Docket Number(s)	NA
Plant/Facility Name	NA
TAC Number(s) (if available)	MB4306
Reference Meeting Notice	ML032120114
Purpose of Meeting (copy from meeting notice)	<u>Forthcoming Meeting with ISA - The Instrumentation Systems, and Aut Automation Society 67.04 Committee Members Regarding Application of Options 1, 2, and 3 In Determination of Allowable Val</u>

NRC MEETING WITH ISA 67.04 COMMITTEE

NRC'S PERSPECTIVE ON ALLOWABLE VALUE

ISA S67.04 Methods of Determining Trip Setpoints and Allowable Values

Method 3:

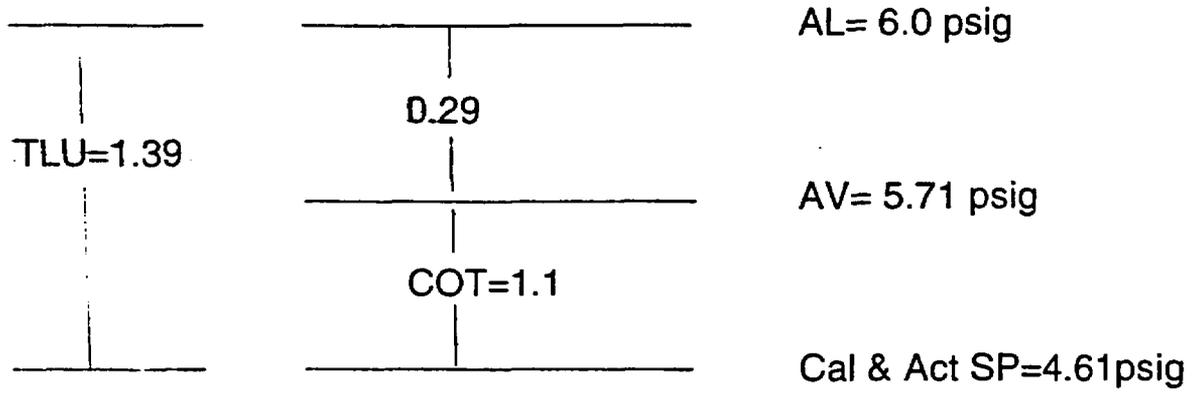
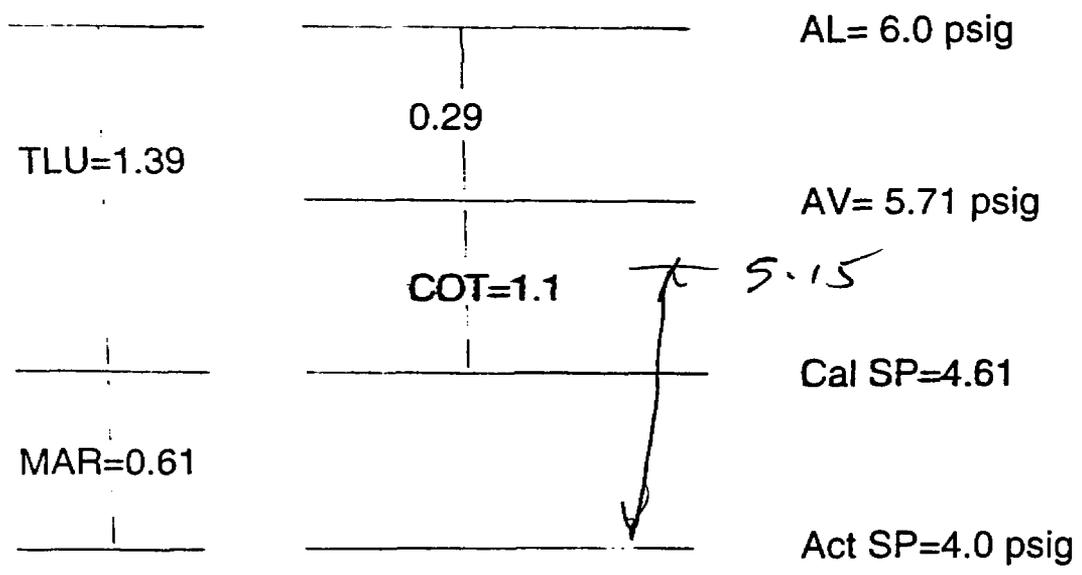
Method 3, and method 3 with additional margin, as shown in the examples, are not acceptable methods for calculating Allowable Values because the methodology permits the "as found" trip setpoint to be greater than 5.15 psig without declaring the channel inoperable. The staff notes that if non-COT uncertainties were added to the "as found" TSP, the instrument channel would exceed its analytical limit and therefore would not preserve the safety limit. Therefore, the channel will not meet the 10 CFR 50.36 requirements for LSSS. However, if the methodology includes a check calculation to provide assurance that the AV is still satisfied by providing a large enough allowance to account for those uncertainties not measured during the test, then method 3 and method 3 with additional margin would be acceptable.
